Three Mile Island Unit I (TMI Unit 1)
Operating License No. DPR-50
Docket No. 50-289

Subject: Additional Information Regarding Kinetic Expansion Inspection and Repair Criteria

RESPONSE TO PRIOR NRC ISSUE/QUESTIONS

FIGURE 1

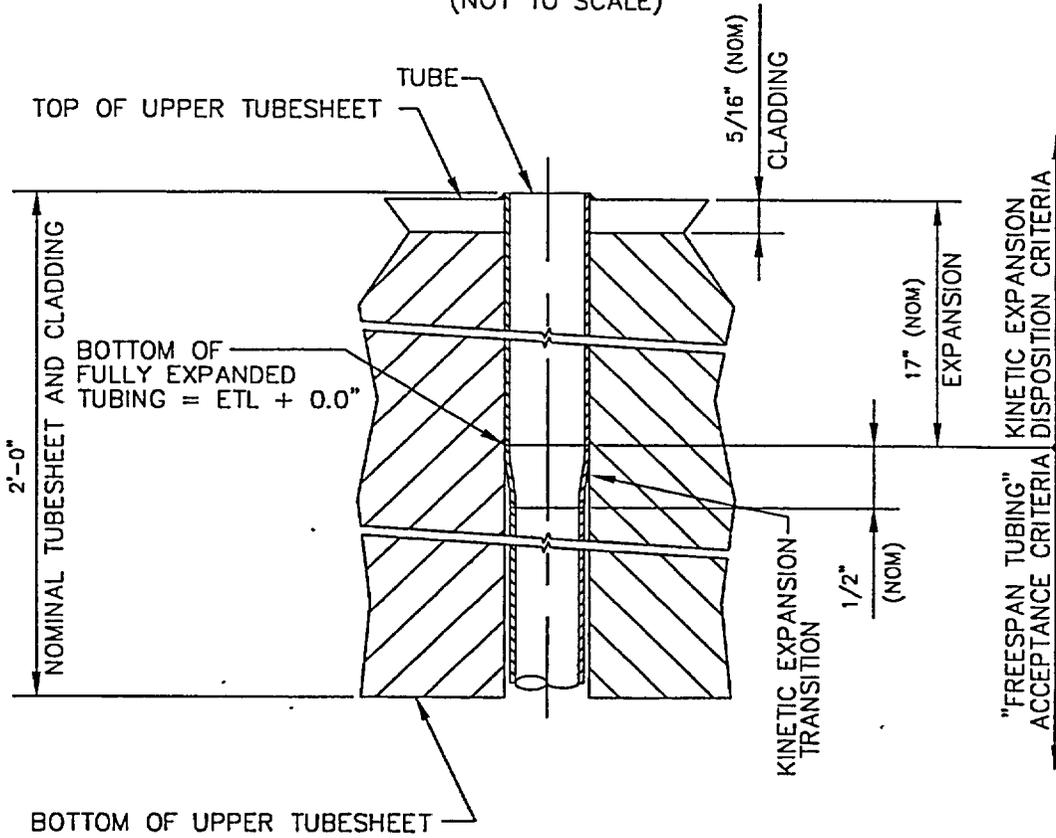
Reference 1 states, *"The licensee states that the structural criteria are based on 6 inches of the kinetic expansion. This would imply that inspection data is routinely collected and assessed on 6 inches of the kinetic expansion. However, the licensee has verbally stated that the actual field practice is to only inspect/assess the minimum distance necessary to identify adequate "defect-free" tubing. This is not clearly documented."*

Reference 1 states: "... *The licensee uses "ETL" to describe the location at which to apply different leakage assessment methodologies. This acronym is not defined in the docketed information.*"

The original 1980's installation of the kinetic expansions was based on a 6" length (e.g. 6" of defect-free material based on a bobbin coil probe examination was required *before* a kinetic expansion was installed), therefore much of the written material has referred to the kinetic expansions as 6" long. In actual practice the in-service tubes were fully expanded to kinetic expansion lengths of either 17" or 22" depth in the upper tubesheets.

As described in the response to question 5, above, the finite element analysis that was used to evaluate the flaw tolerance of the kinetic expansions was a 6" long model (consisting of 5.5" of fully expanded tubing and a 0.5" transition.)

As described above, TMI-1 uses required kinetic expansion lengths that are conservative and are longer than those defined by the analysis model. TMI inspects and dispositions only these required expansion lengths. (Refer to Table 1, below.) A TMI-1 eddy current analyst reviews the tube's MRPC signal to locate the top of the kinetic expansion transition (i.e., that point where the tube is fully kinetically expanded against the tubesheet bore). This point is designated by the eddy current analyst as ETL+0.00". (ETL = Expansion Transition Location) The analyst reviews the eddy current signals from the fully-expanded section; if no flaws are detected over the minimum required defect free length then the tube is dispositioned as "NDD" (i.e., No Detectable Degradation). If a flaw is detected, it is characterized, located with respect to the ETL+0.00" reference point, and additional kinetic expansion length is reviewed by the analyst to detect/characterize any other flaws that might be present. If the additional analyzed length contains flaws such that sufficient defect free tubing is not identified, the tube is repaired. If the additional kinetic expansion length is analyzed and sufficient defect free tubing length is identified, the expansion then may be left in service (provided it meets all other criteria to remain in service).

Figure 1, which follows, provides an illustration of a typical kinetic expansion.

Refer to Figures 1 and 2, above. ETL is an acronym created by TMI-1 that stands for "Expansion Transition Location". ETL + 0.00" is that point at the top of the kinetic expansion transition where the tubing is fully expanded against the tubesheet bore. Indications in the TMI-1 kinetic expansions are located with respect to this point (e.g., one indication may be located at ETL + 3.45", while another indication might be located at ETL - 0.16".)

FIGURE 2
“Defect Free” Concept

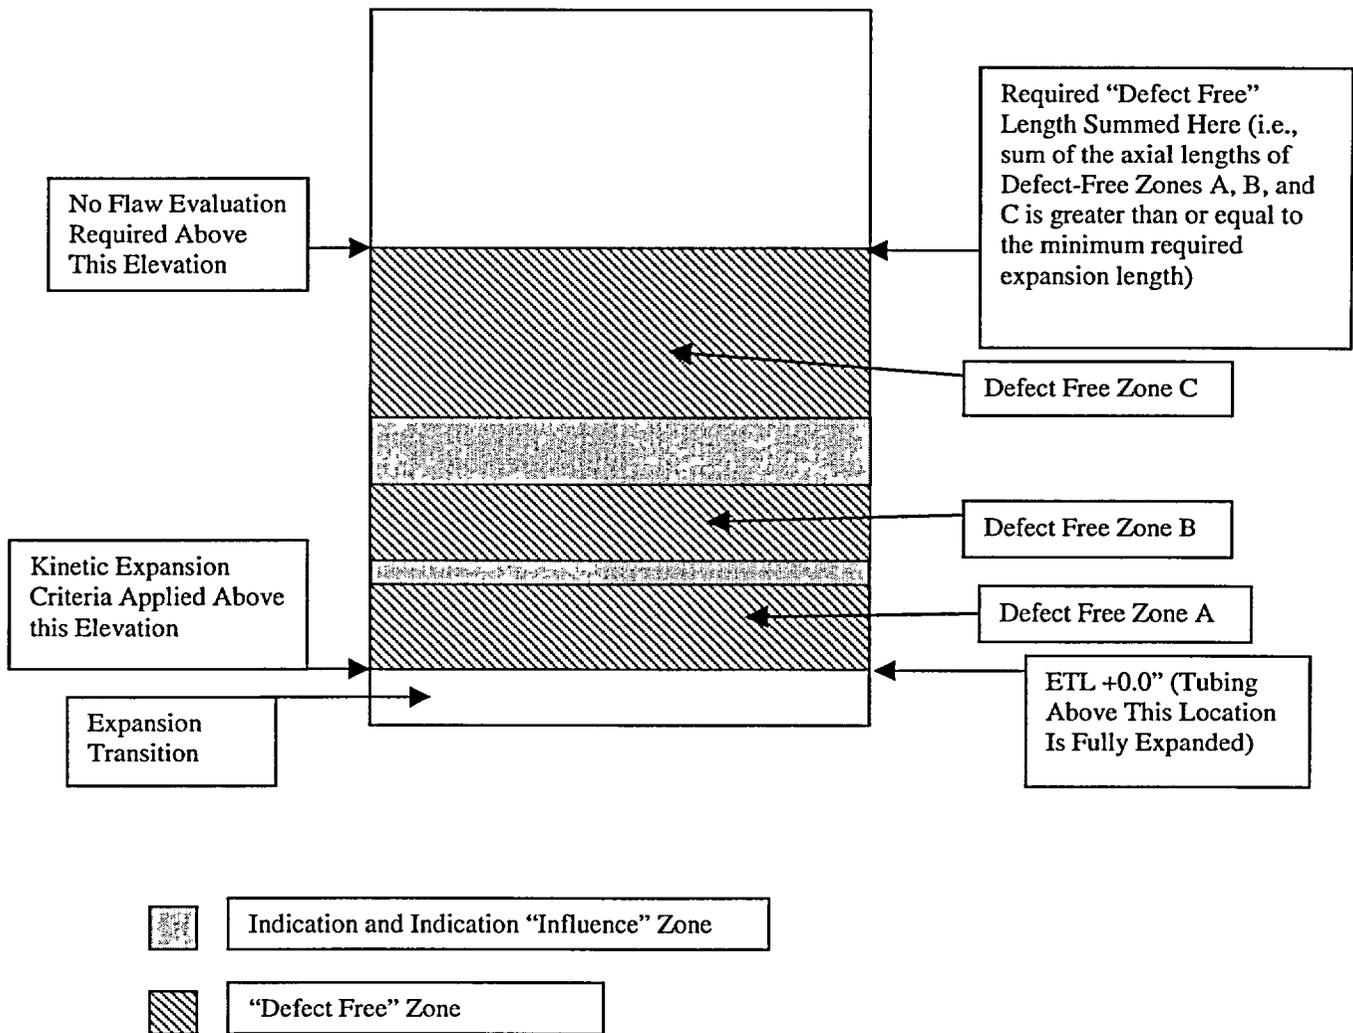
Reference 1 states, *"In the context of the preceding issues, the licensee needs to specify what actions would be taken if insufficient defect-free tubing is identified in the full qualification length. For example, would the inspection for sufficient defect-free tubing be allowed to continue higher in the tubesheet? The NRC staff requests that the licensee provide the technical basis for continued inspection or for other actions that would be taken."*

TMI-1 does not use the phrase "full qualification length" in its kinetic expansion acceptance criteria. As described in the above responses, kinetic expansion evaluations are performed beginning at the ETL + 0.00" location to verify that sufficient defect-free lengths are present.

Structural evaluations of the kinetic expansions require that a kinetic expansion be removed from service if insufficient defect-free length is identified over its examined length. That is, if a defect (or a combination of defects) is detected that exceeds the allowable circumferential extent acceptance criterion, or an insufficient axial length of defect-free expansion is present, the expansion is removed from service. The inspection of a kinetic expansion may proceed farther (i.e., higher) in the tubesheet if flaws detected during the course of the examination within that expansion are within the conservative structural acceptance criteria. Figure 2, below, provides a visual presentation of the “defect-free” concept for a kinetic expansion with two indications.

MPR Report 1820, Rev 1., Table 3-5, describes the conservative criteria with which flaw indications in the kinetic expansions are evaluated. If a flaw is detected in a kinetic expansion the TMI-1 dispositioning criteria conservatively assume that the joint is not usable for structural purposes over the entire axial length of that flaw. For example, if a small volumetric flaw is detected with an eddy current-measured axial extent of 0.15”, the entire 0.15” length of the expansion (360 degrees around the surface of the tube) is not credited in the evaluation of the joint structural integrity. In addition, no credit is taken for defect-free tubing along additional axial lengths of the joints adjacent to flaws (known as flaw “influence zones”). Even small circumferentially-oriented flaws, if present, are assigned axial lengths of flaw influence zone so that no credit is given for that axial influence zone length of the entire joint. In summary, sufficient defect-free tubing must be detected to verify the integrity of an expansion during an inspection; no credit is taken for the length of the kinetic expansion where any defect is present, or where any defect might influence joint integrity.
